EPC STORMWATER REVIEW COMMENTS
IN ORANGE BOXES WITH BLACK TEXT

Drainage Letter

The Landings of Denmark

PCD Proj No.: CDR-22-012

THE LANDINGS OF DENMARK
FILING NO. 2
FINAL DRAINAGE BASIN MAP
PROPOSED CONDITIONS

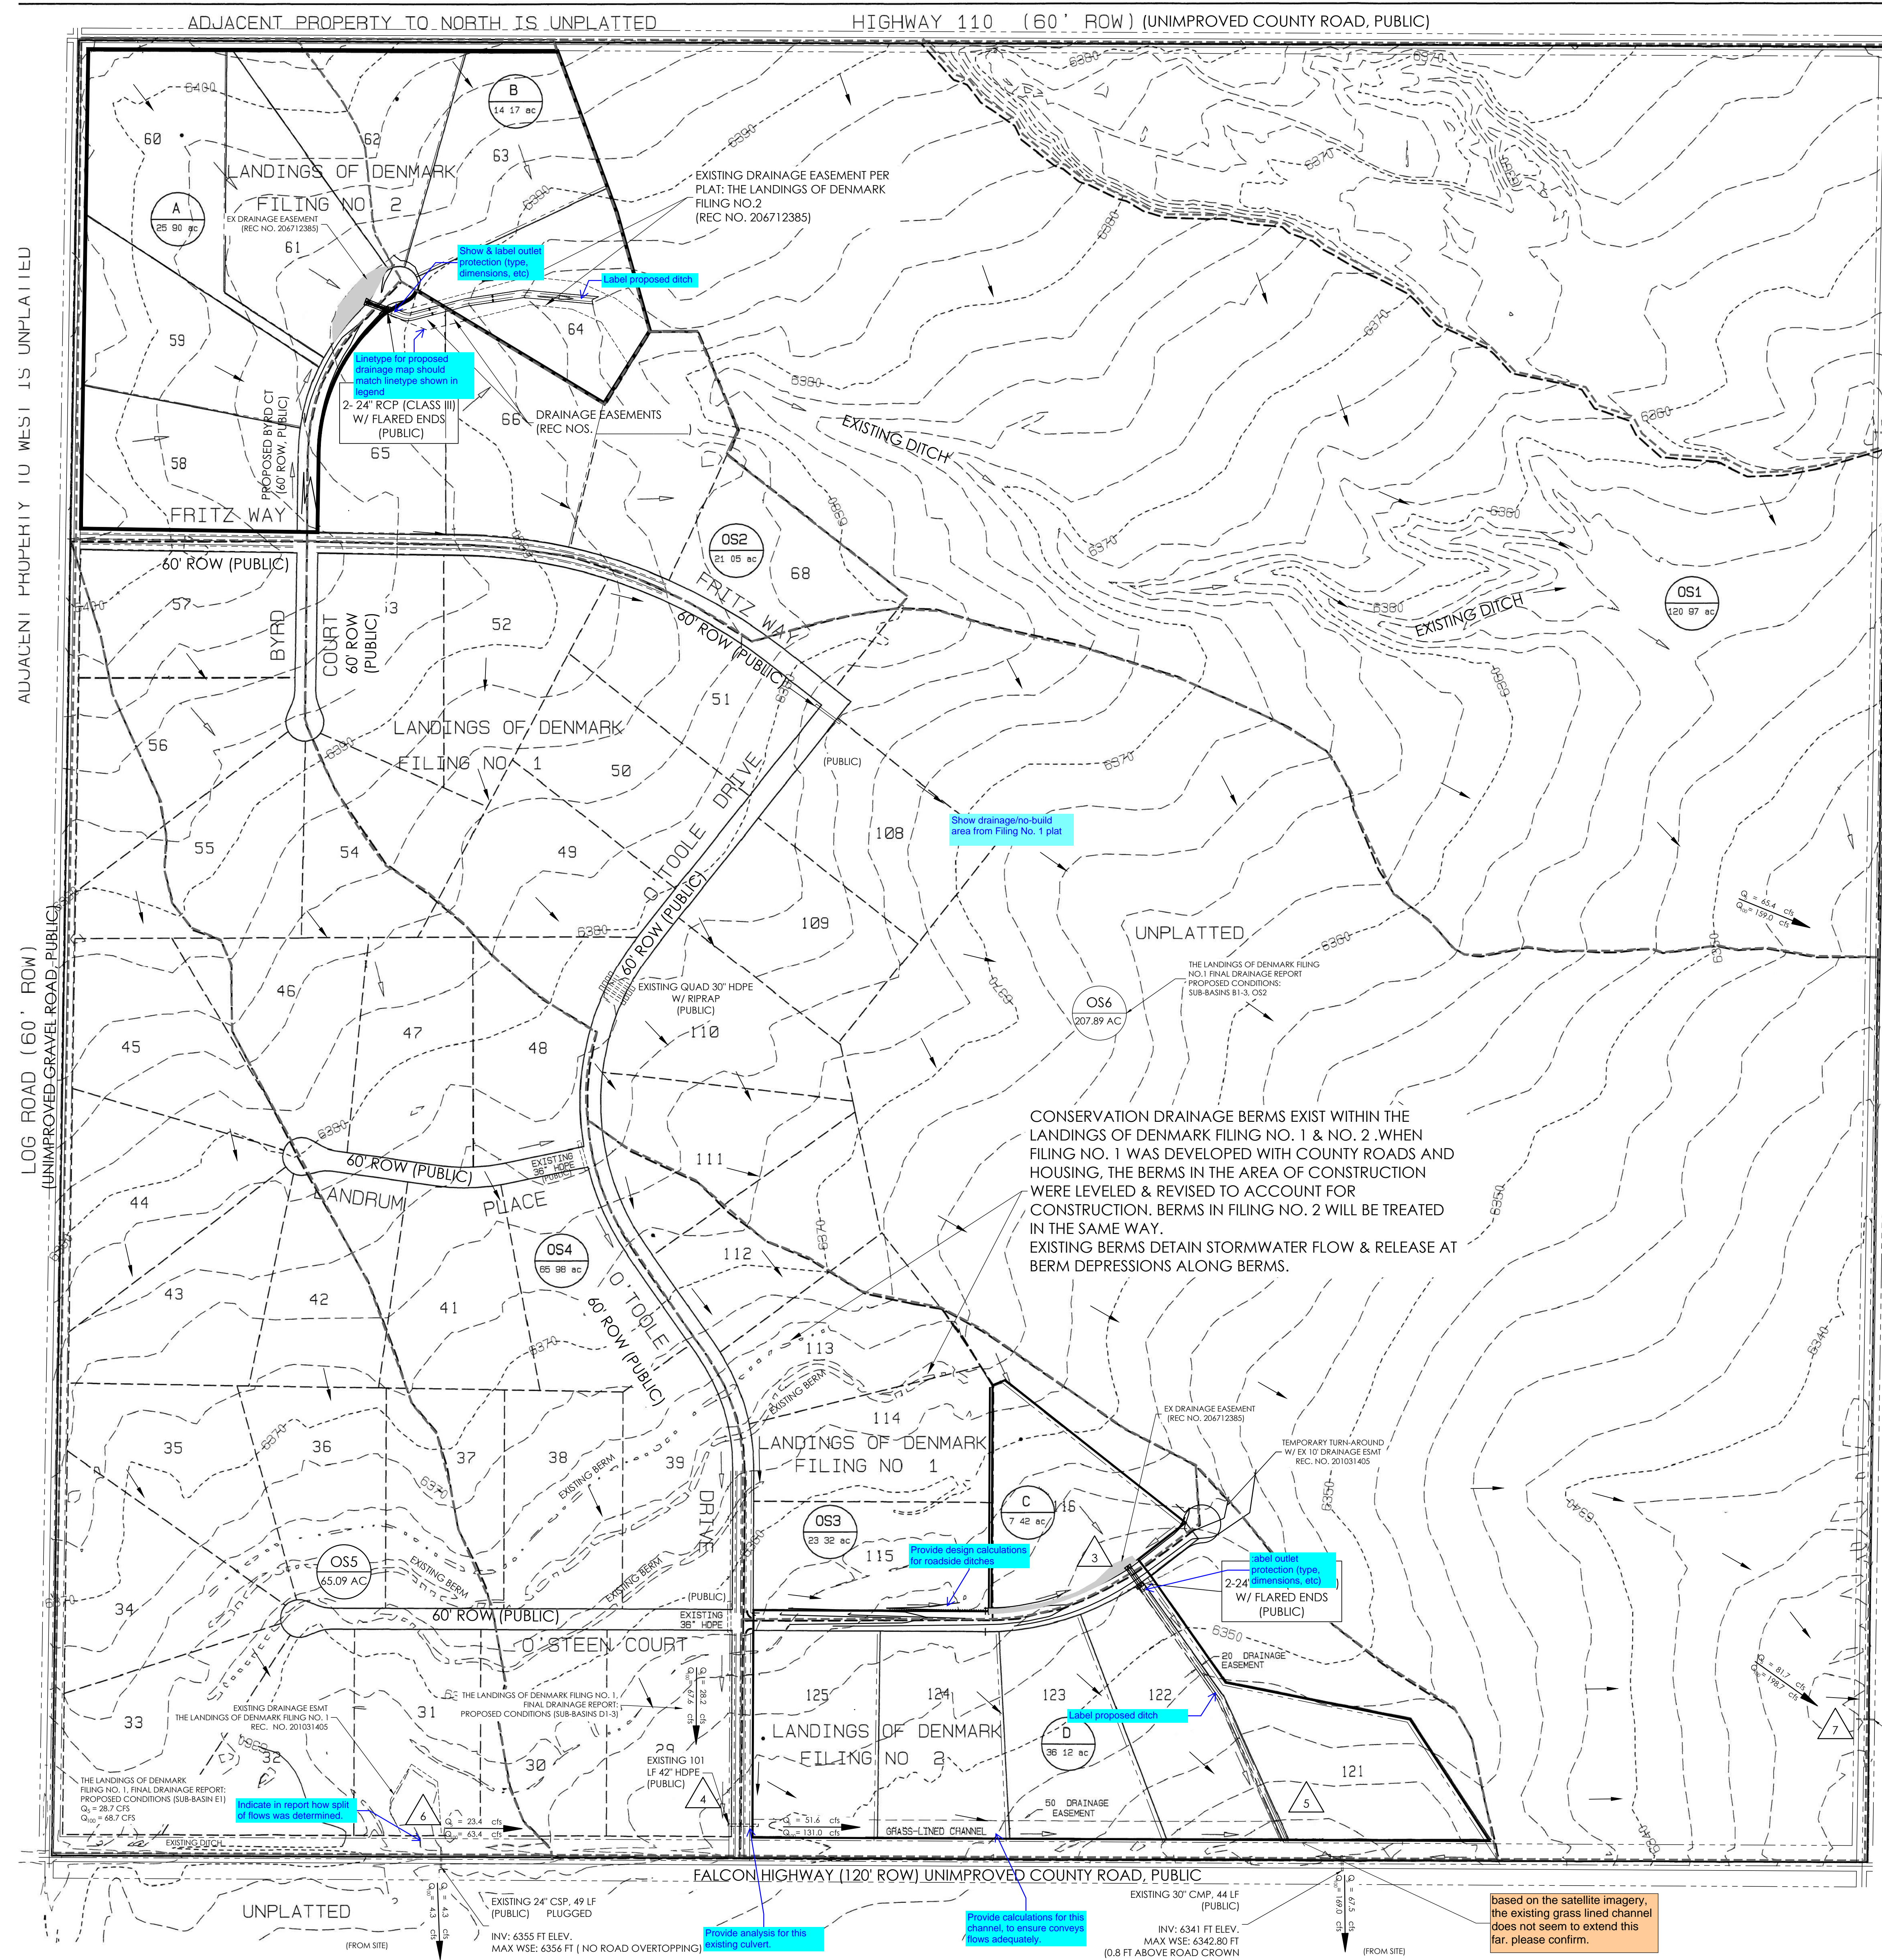
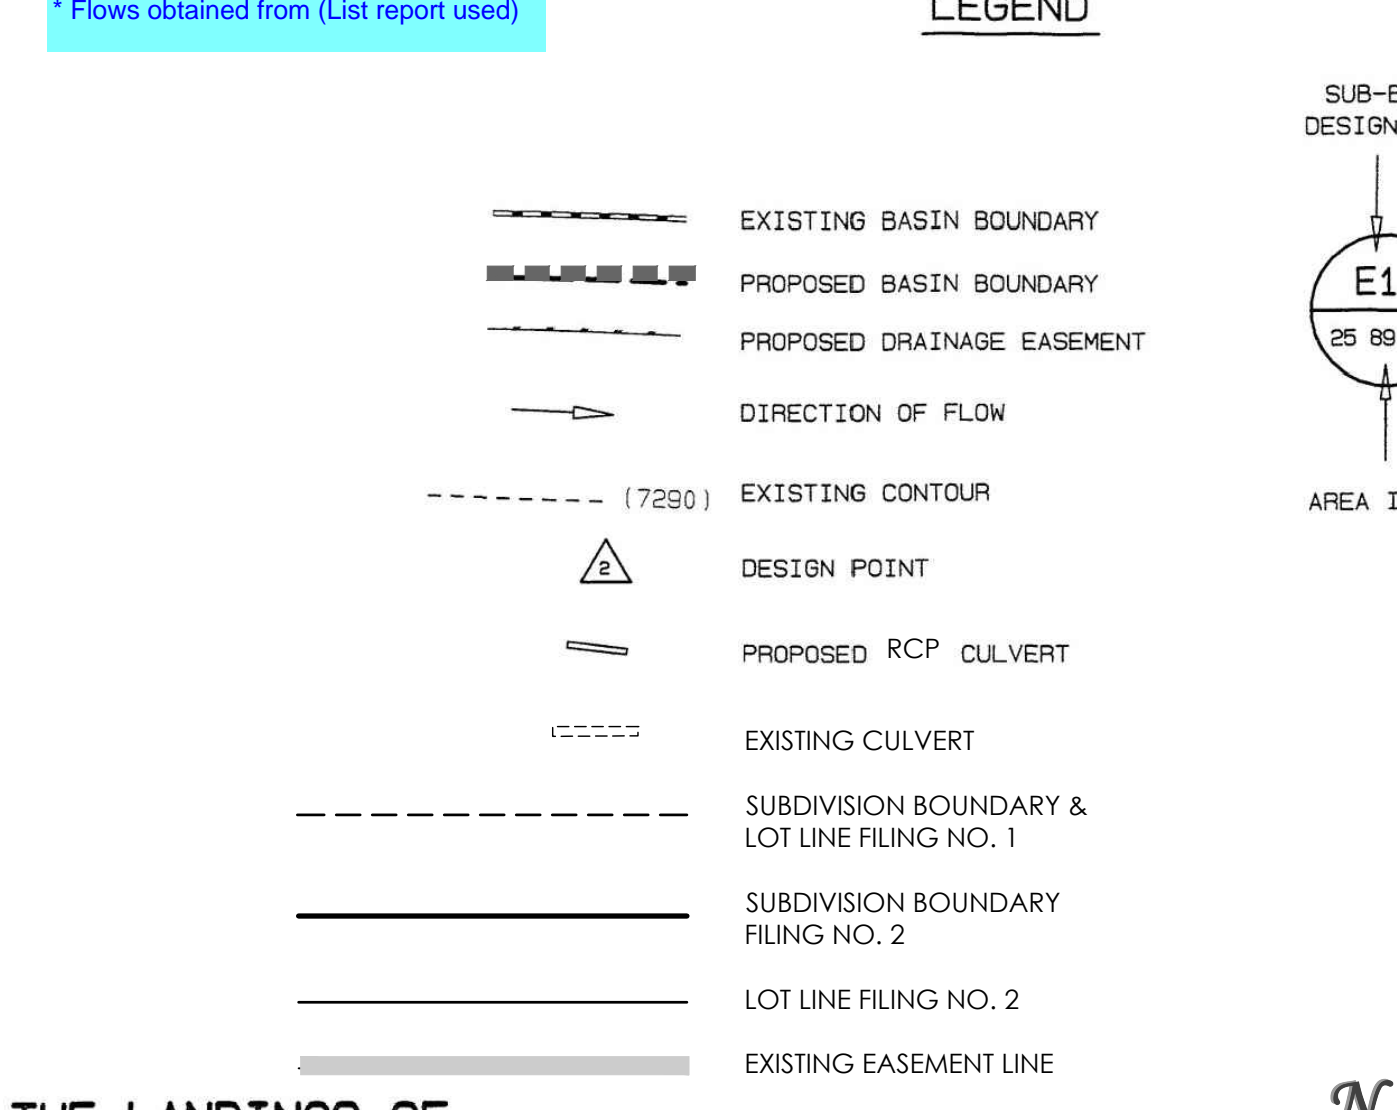
Flows shown at DP: 5 are for nearby information in hydrology spreadsheet. Please reconcile and update pages accordingly.

Flows obtained from (List report used)
